## **REMARKS**

### **A. SUMMARY OF THE AMENDMENTS**

### **B. OBJECTION TO THE DRAWINGS**

FIG. 1

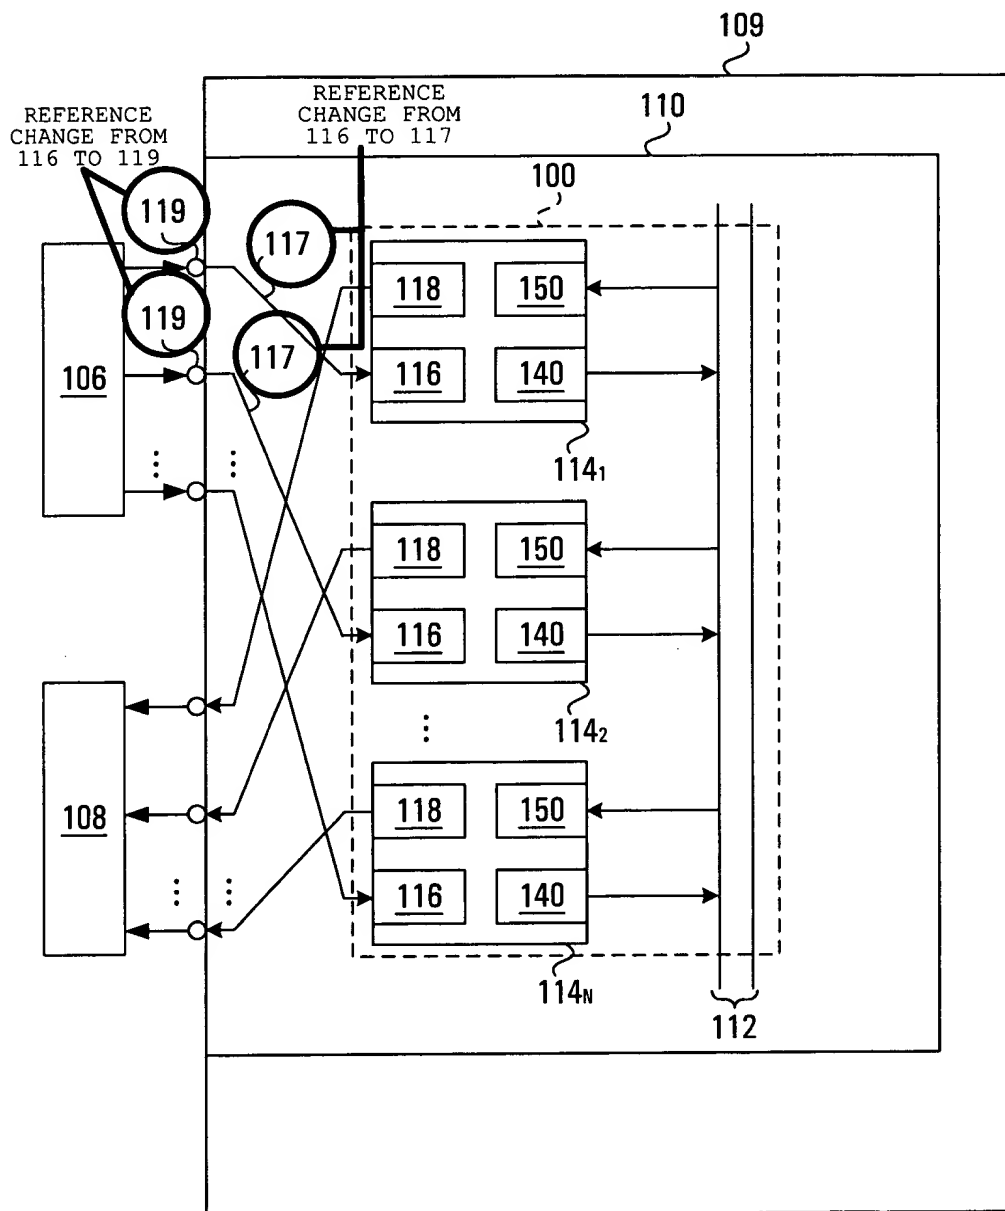
Fig. 1

The Examiner has objected to Fig. 1 for using reference numbers " 116' " and " 116" " containing inverted commas. In response, the Applicant has amended Fig. 1 and the accompanying portion of the description such that "traces 116" " and "releasable connector 116' " have been replaced by "traces 117" and "releasable connector 119", respectively.

In Fig. 1, reference signs 116" and 116' have been changed to 117 and 119, respectively.

FIG. 5

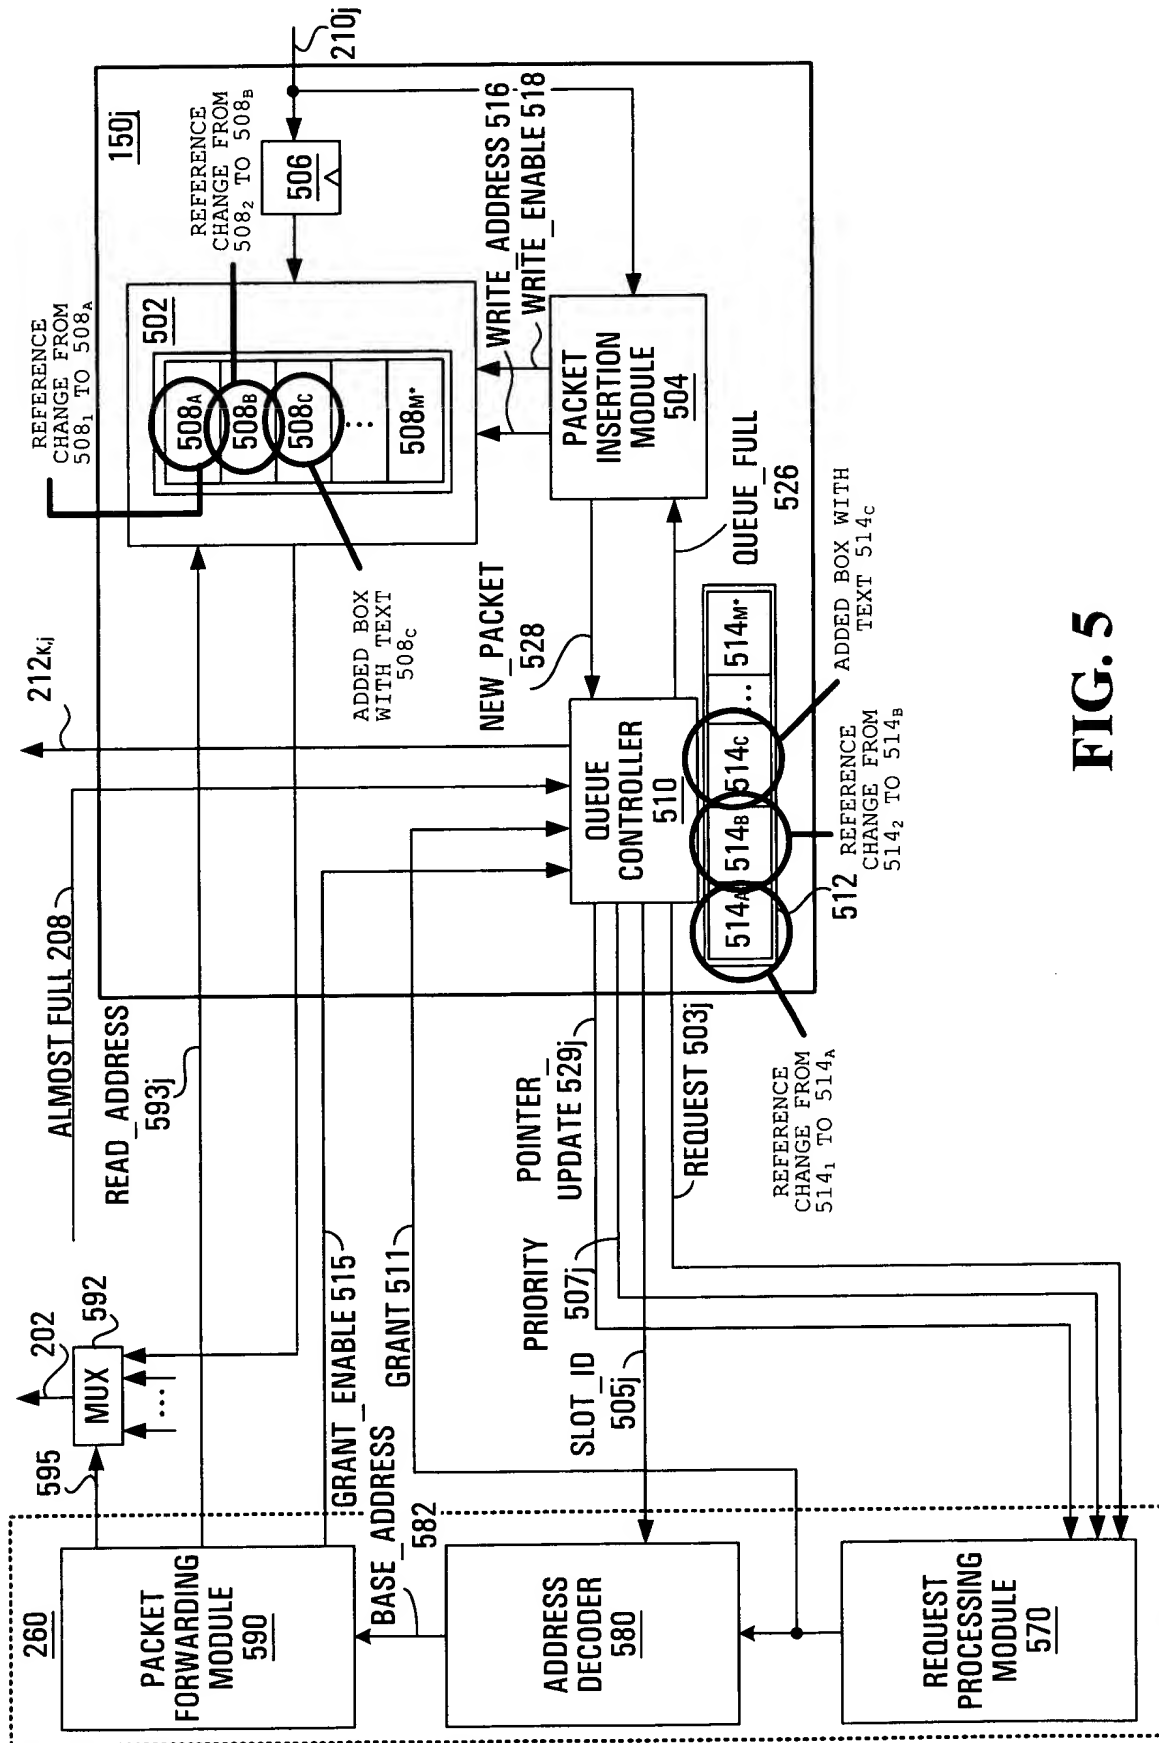
The Examiner has objected to Fig. 5 for failing to include the reference signs corresponding to "slots 508<sub>A</sub>, 508<sub>B</sub>, 508<sub>C</sub>" and "entries 514<sub>A</sub>, 514<sub>B</sub>, 514<sub>C</sub>". In response, the Applicant has amended Fig. 5 and respectfully submits that Fig. 5 is in full compliance with 37 CFR 1.84(p)(5).

In Fig. 5, reference signs 508<sub>1</sub> and 508<sub>2</sub> have been replaced with reference signs 508<sub>A</sub>, 508<sub>B</sub>, 508<sub>C</sub>, and reference signs 514<sub>1</sub> and 514<sub>2</sub> have been replaced with reference signs 514<sub>A</sub>, 514<sub>B</sub>, and 514<sub>C</sub>.

FIG. 9

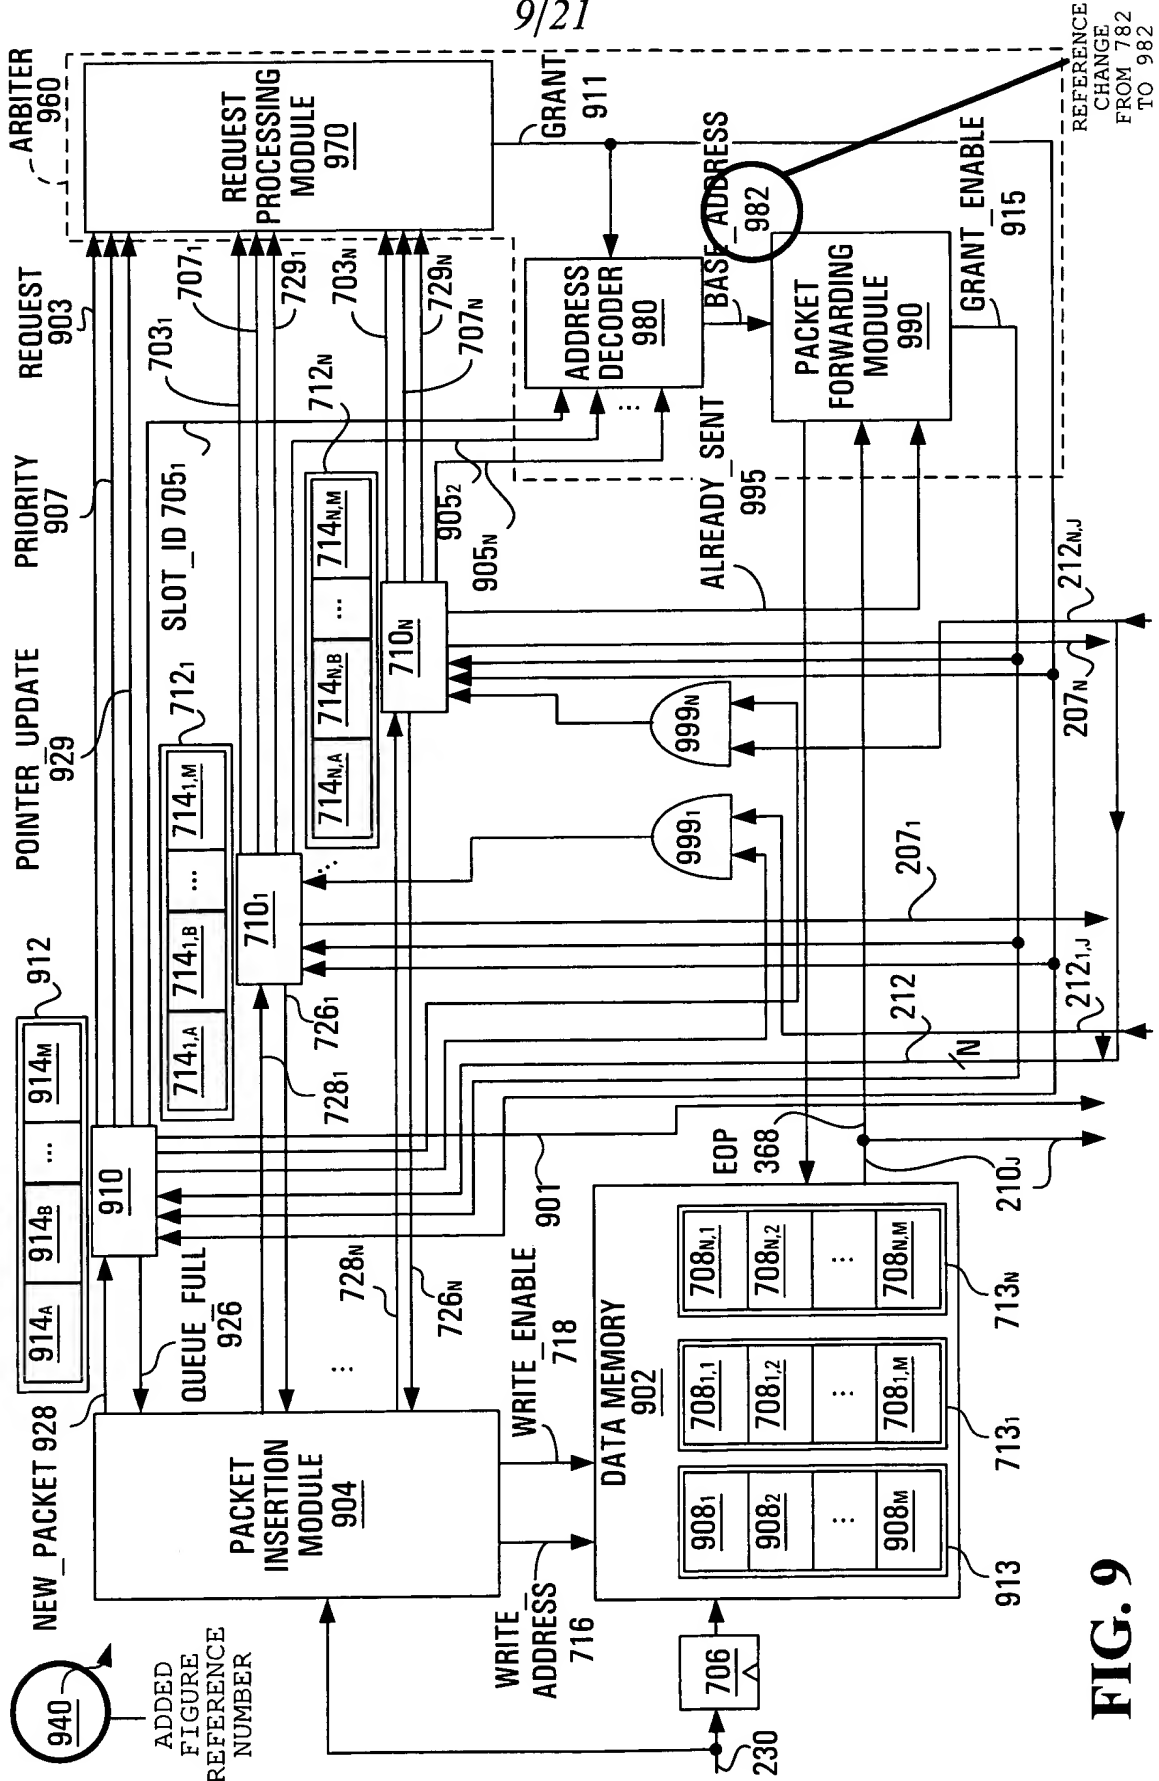
The Examiner has objected to Fig. 9 for failing to include the reference signs corresponding to "transmitter 940" and "base\_address line 982". In response, the Applicant has amended Fig. 9 and respectfully submits that Fig. 9 is in full compliance with 37 CFR 1.84(p)(5).

In Fig. 9, reference sign 940 has been added to refer to the entirety of the Figure and reference sign 982 has been added to refer to the BASE\_ADDRESS line.

FIG. 14

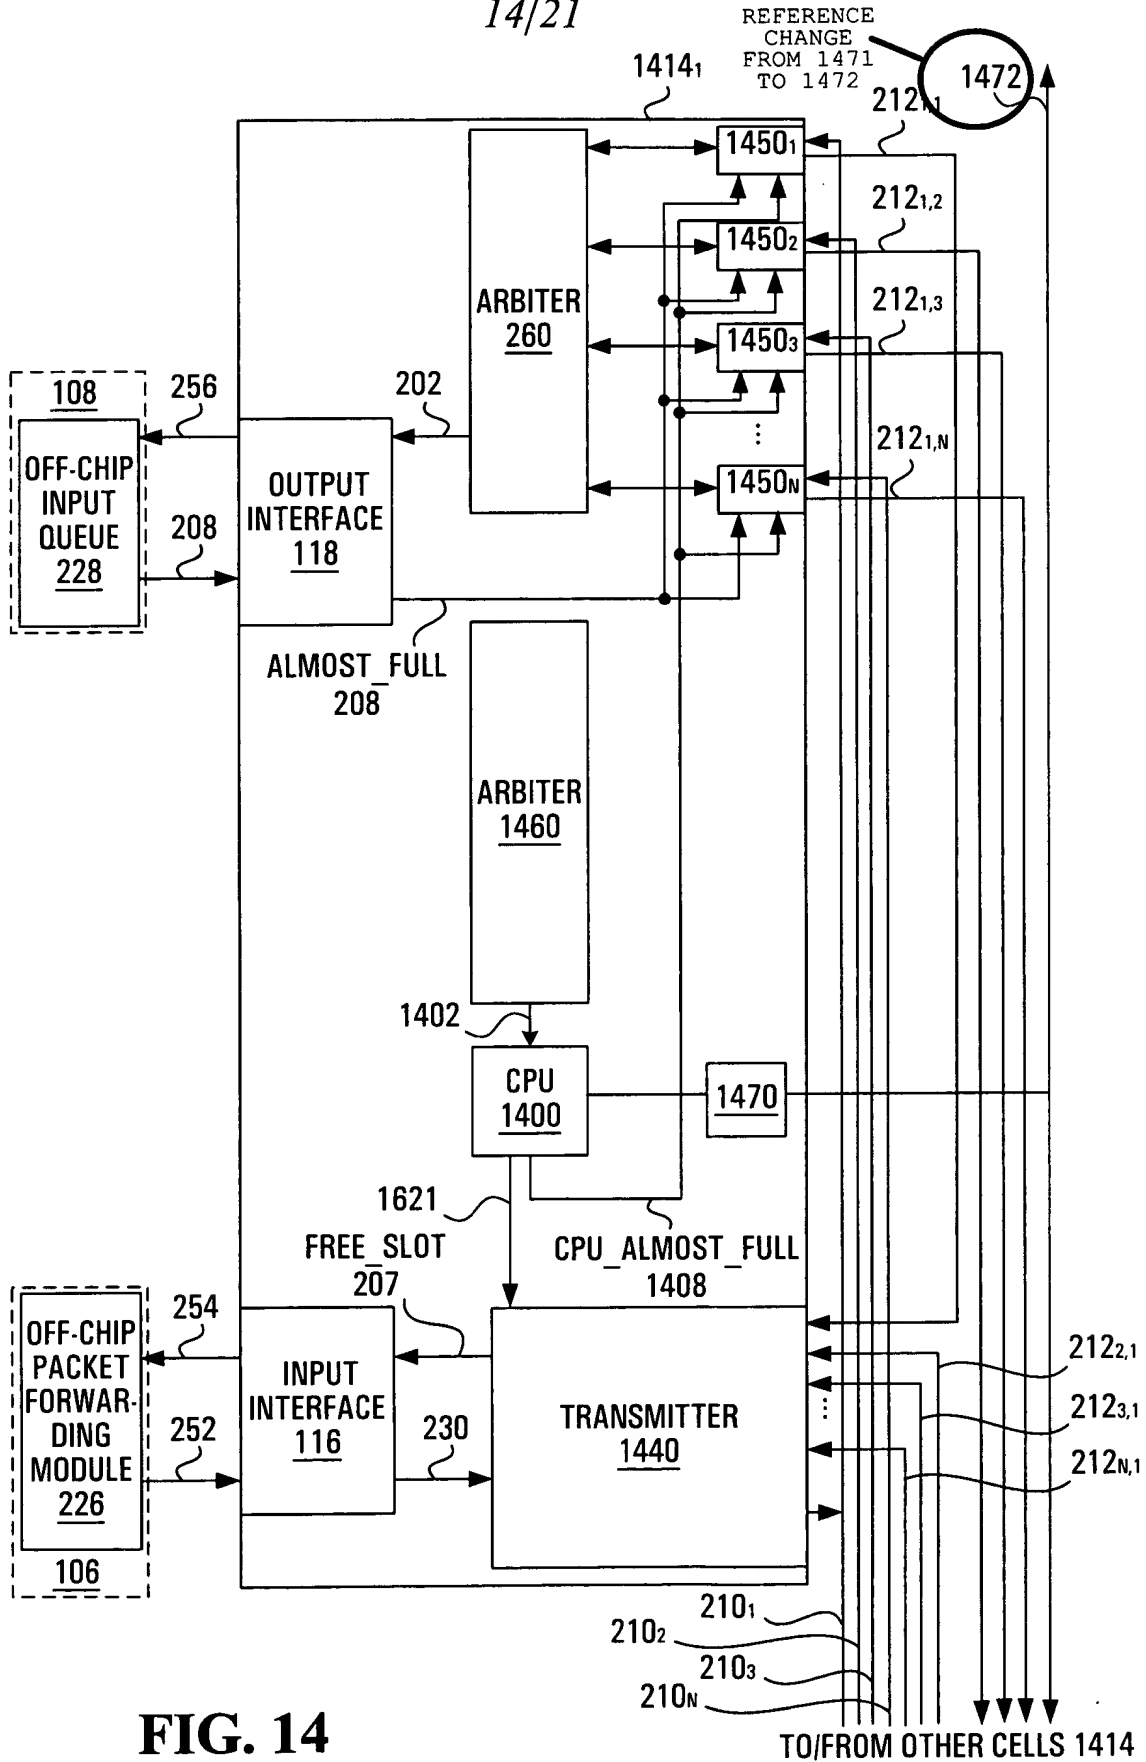
The Examiner has objected to Fig. 14 for failing to include the reference signs corresponding to "bus 1472". In response, the Applicant has amended Fig. 14 and respectfully submits that Fig. 14 is in full compliance with 37 CFR 1.84(p)(5).

In Fig. 14, reference sign 1472 has been added to refer to the bus on the far right-hand side of the Figure.

FIG. 20

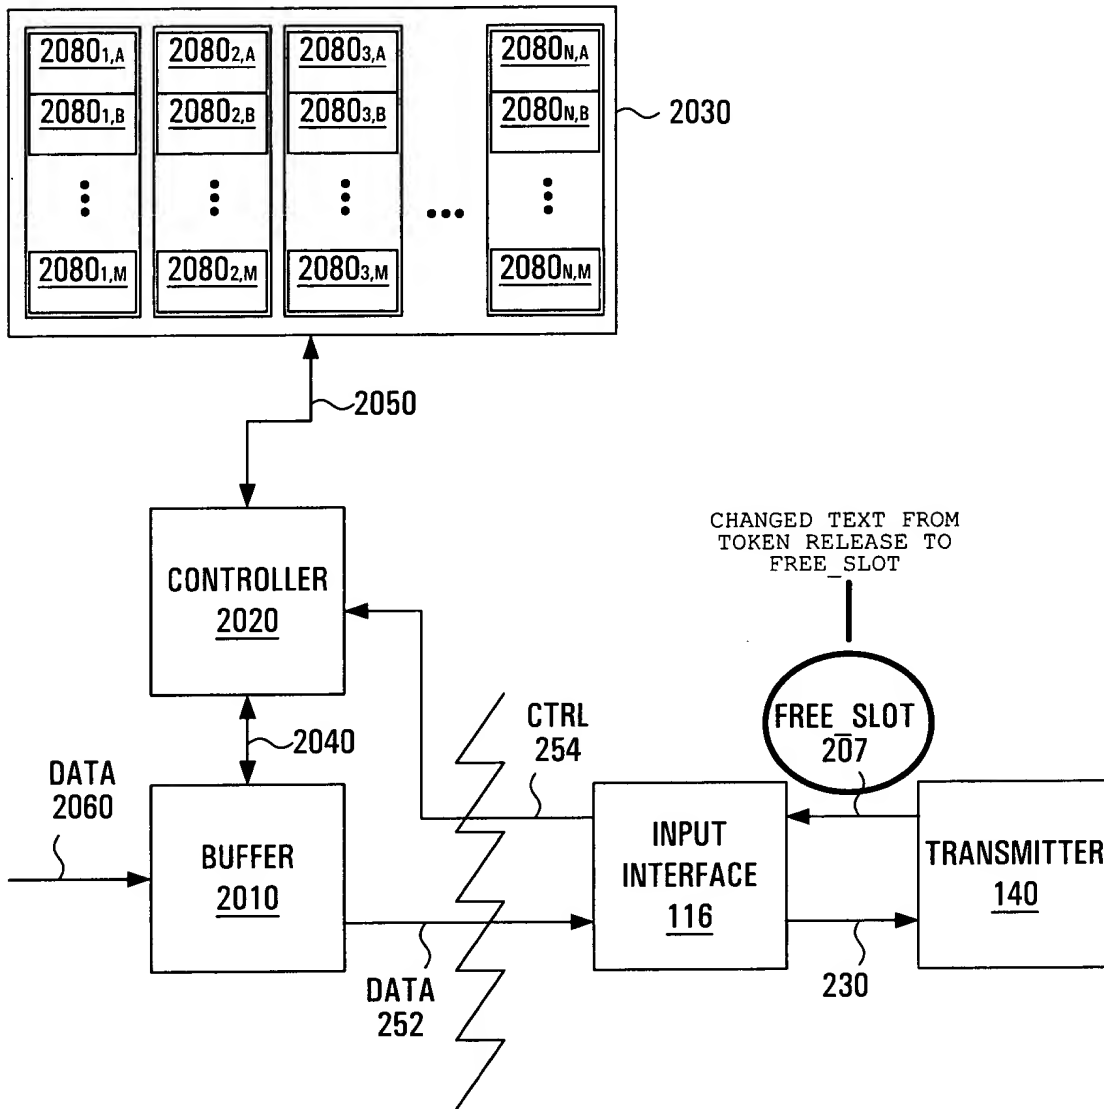
The Examiner has objected to Fig. 20 for failing to include the reference signs corresponding to "free\_slot lines 207". In response, the Applicant has

amended Fig. 20 and respectfully submits that Fig. 20 is in full compliance with 37 CFR 1.84(p)(5).

In Fig. 20, reference sign 207 has been added to the free\_slot line between transmitter 140 and input interface 116.
